Bidding and Contract Requirements
Addendum No. 3

Subject: Addendum No. 3 to the Bidding Documents for:

ILEAS Air Handling Unity Replacement (2026-001)
County of Champaign
Urbana, Illinois

LARGE SCALE VENTILATION DEMOLITION - BASEMENT MECHANICAL ROOM

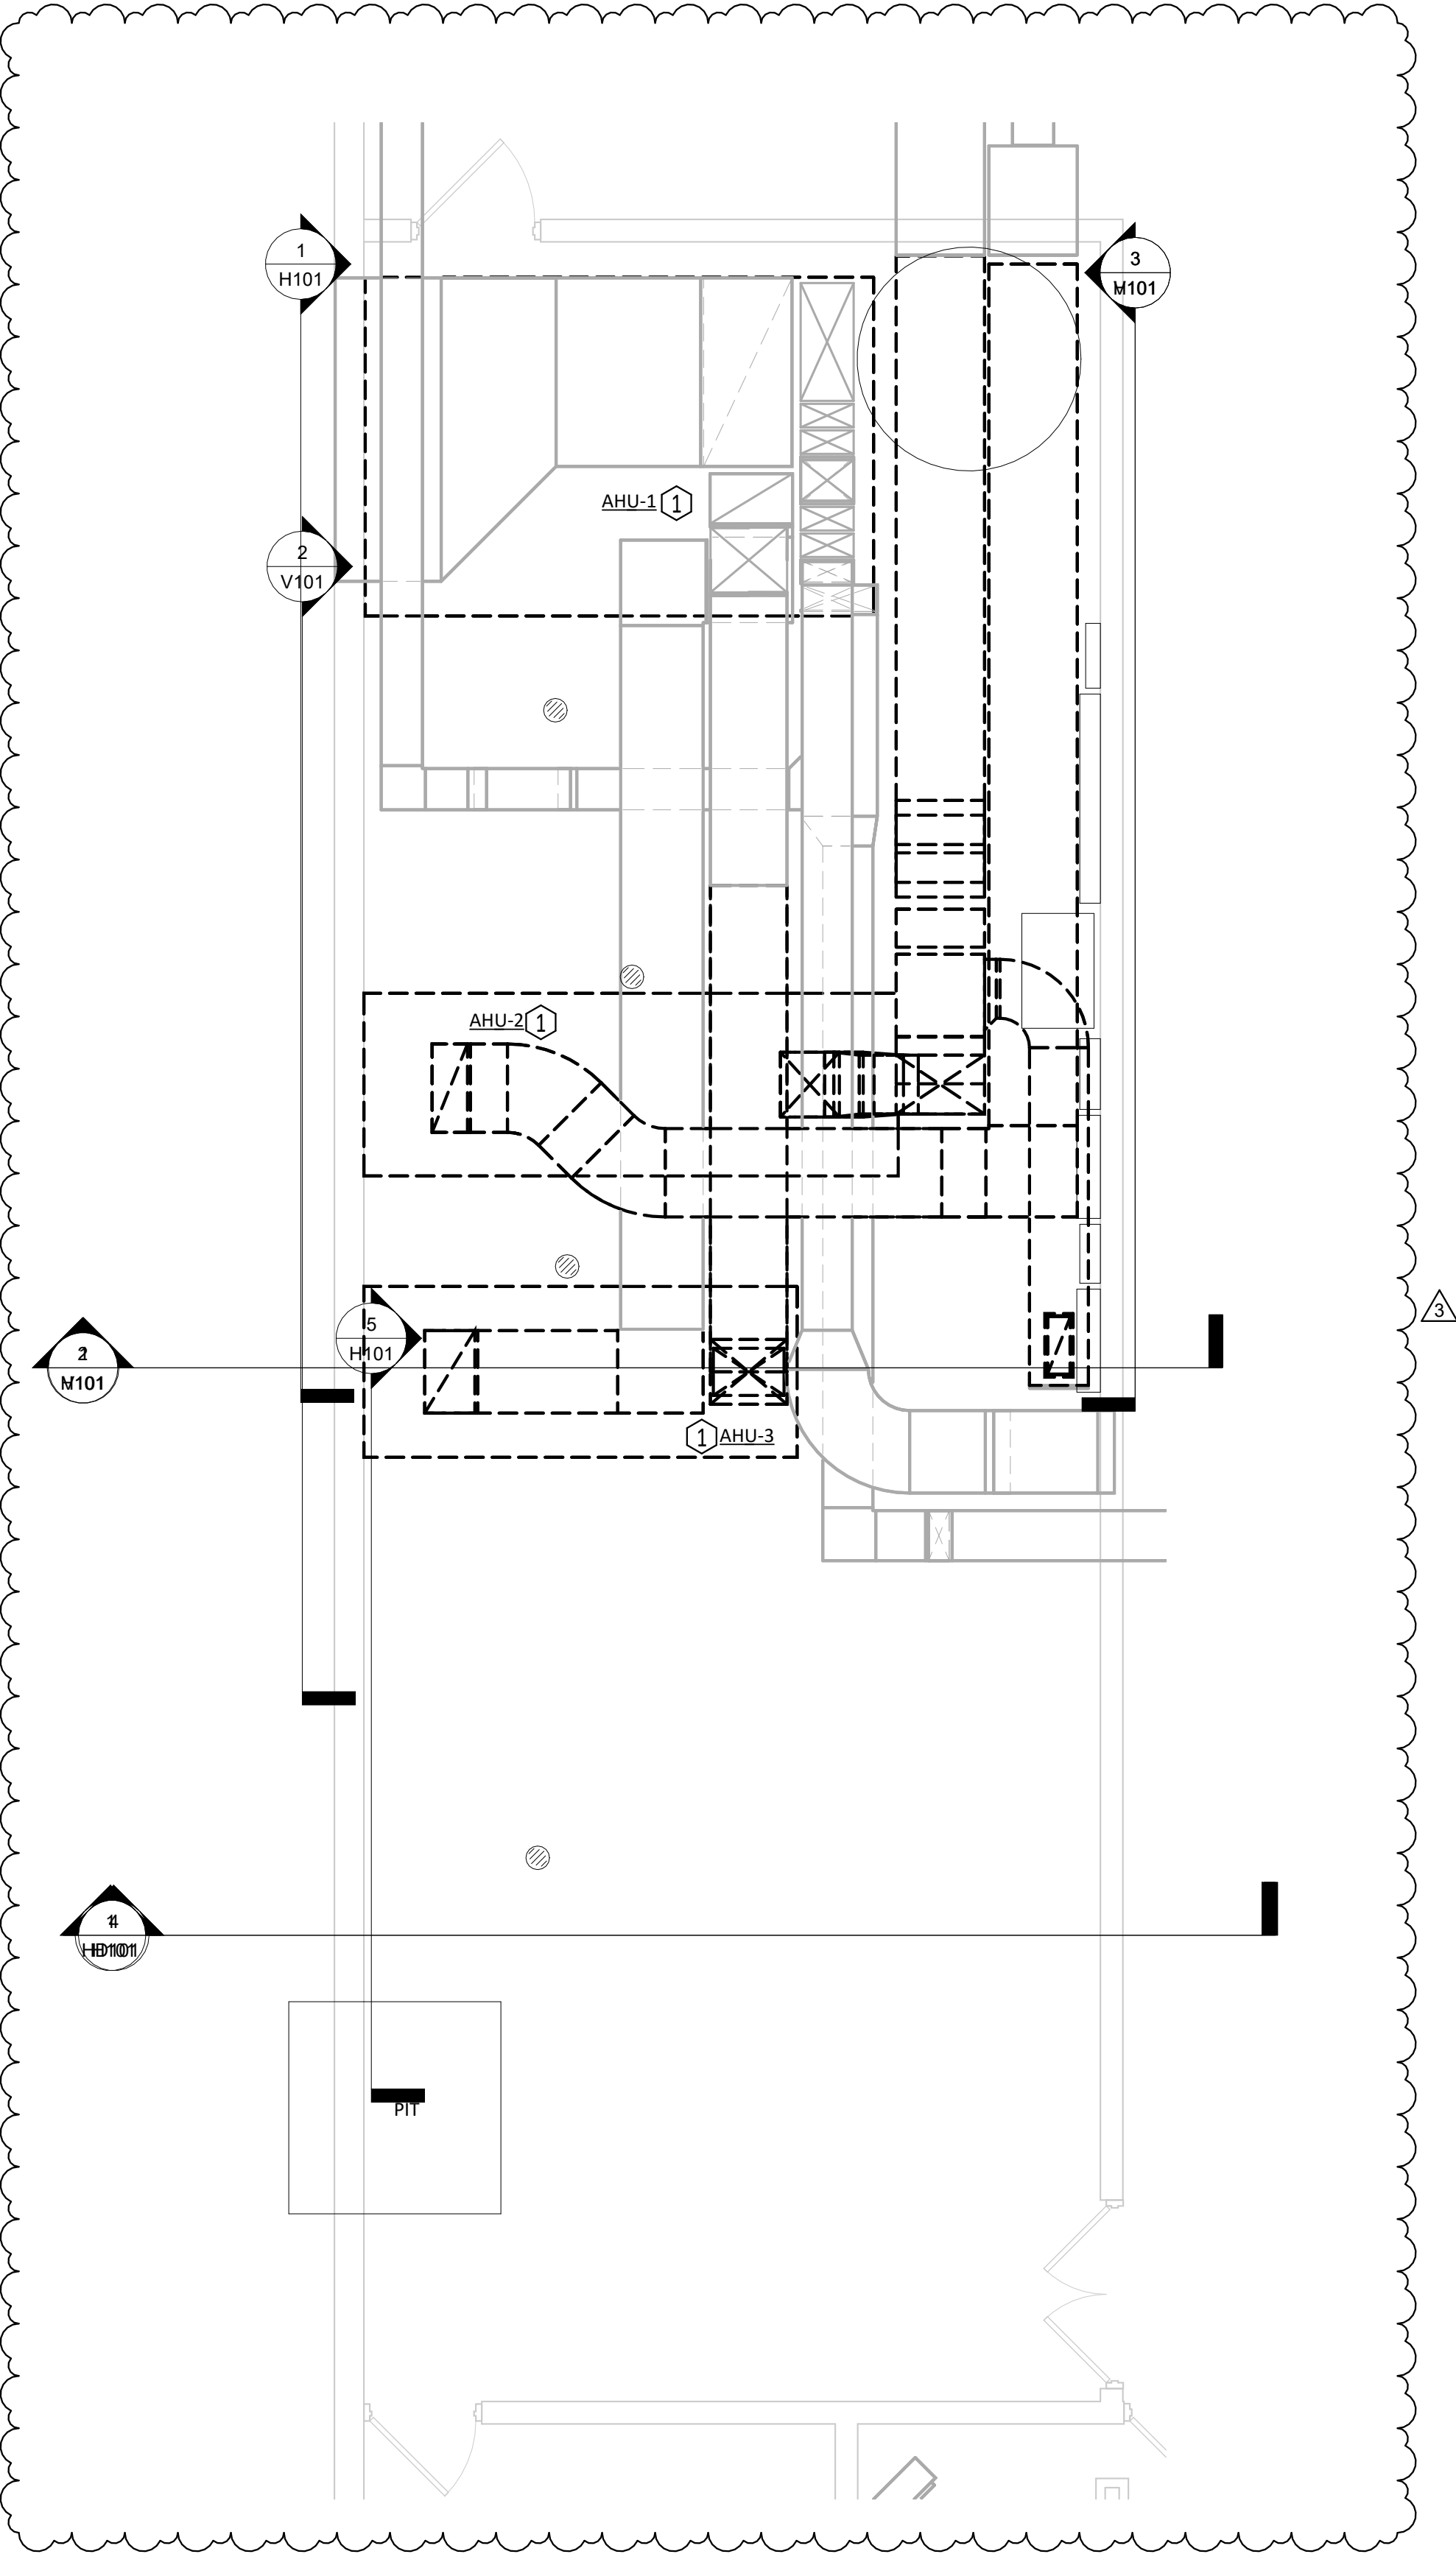
1. Sheet H101 - Large Scale Heating - Basement Mechanical Room
 - a. REVISED orientation of AHU-2 to run N-S.
 - b. REVISED piping to AHU-2 per the re-orientation.
2. Sheet VD101 - Large Scale Ventilation Demolition - Basement Mechanical Room
 - a. Sheet VD101 - Large Scale Ventilation Demolition - Basement Mechanical Room
3. Sheet V101 - Large Scale Ventilation - Basement Mechanical Room
 - a. REVISED orientation of AHU-2 to run N-S.
 - b. REVISED ductwork to AHU-2 per the re-orientation.
4. Sheet HV200 - Schedules and Details - Mechanical
 - a. REVISED AHU schedule notes to better coordinate housekeeping pad instructions with existing obstructions and to better serve the re-oriented
